To: T10 Technical Committee  
From: Rob Elliott, HP (elliott@hp.com)  
Date: 22 December 2006  
Subject: 06-373r1 SAS-2 Zone manager key

## **Suggested changes**

**Figure 53 — Physical presence detection extending a ZPSDS example [no change]**

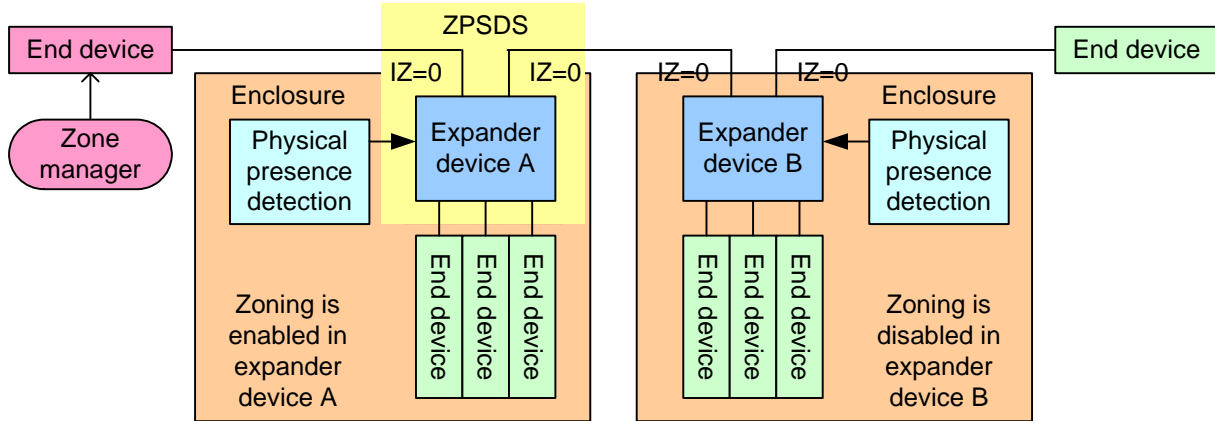
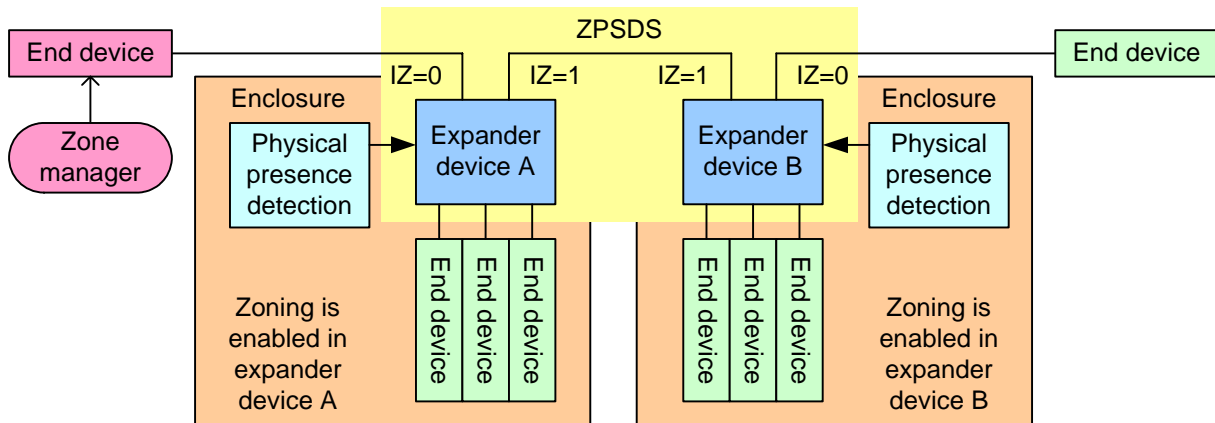
Figure 53 shows an example of two enclosures with physical presence detection where zoning is enabled in the expander device in the left enclosure, but is not enabled in the expander devices in the right enclosure. The zone manager is able to configure zoning in zoning expander device A because the zone group of its SMP initiator port has access to zone group 2. However, it is not able to enable or configure zoning in expander device B unless physical presence is asserted [or it presents the current zone manager key.](#)

configure zoning in expander device B unless physical presence is asserted [or it presents the current zone manager key](#).

**Figure 54 — Physical presence detection overtaking a ZPSDS example [no change]**

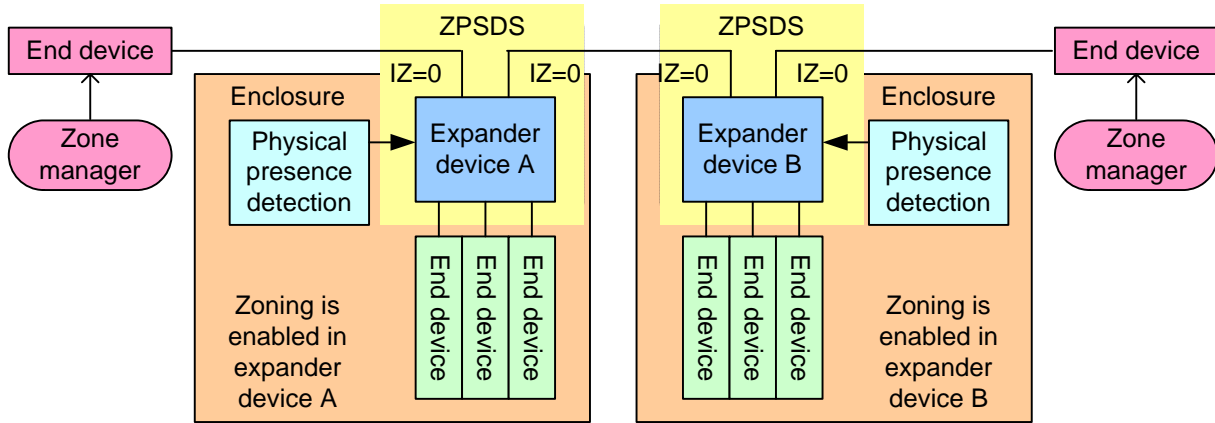
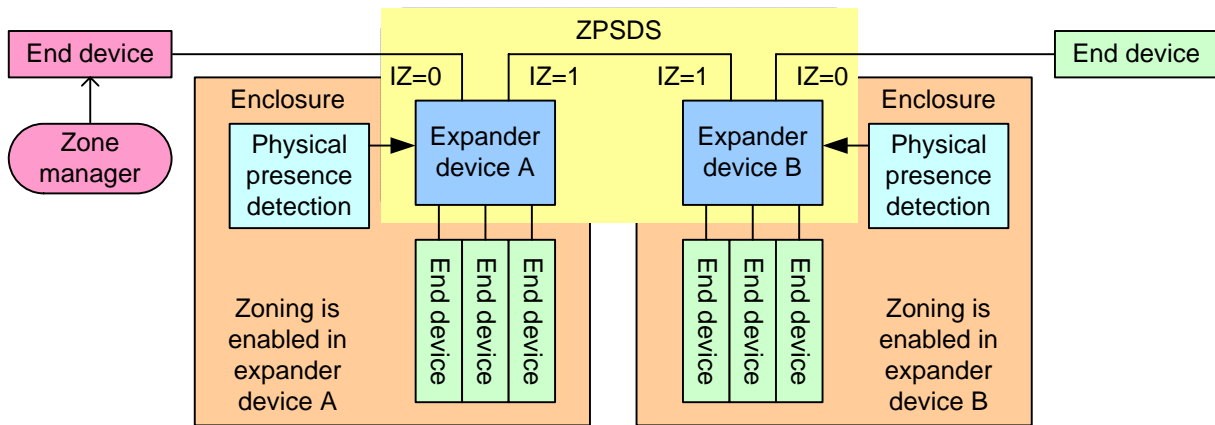
Figure 54 shows an example of two enclosures with physical presence detection where zoning is enabled in both the expander devices. The zone manager is able to configure zoning in zoning expander device A because the zone group of its SMP initiator port has access to zone group 2. However, it is not able to
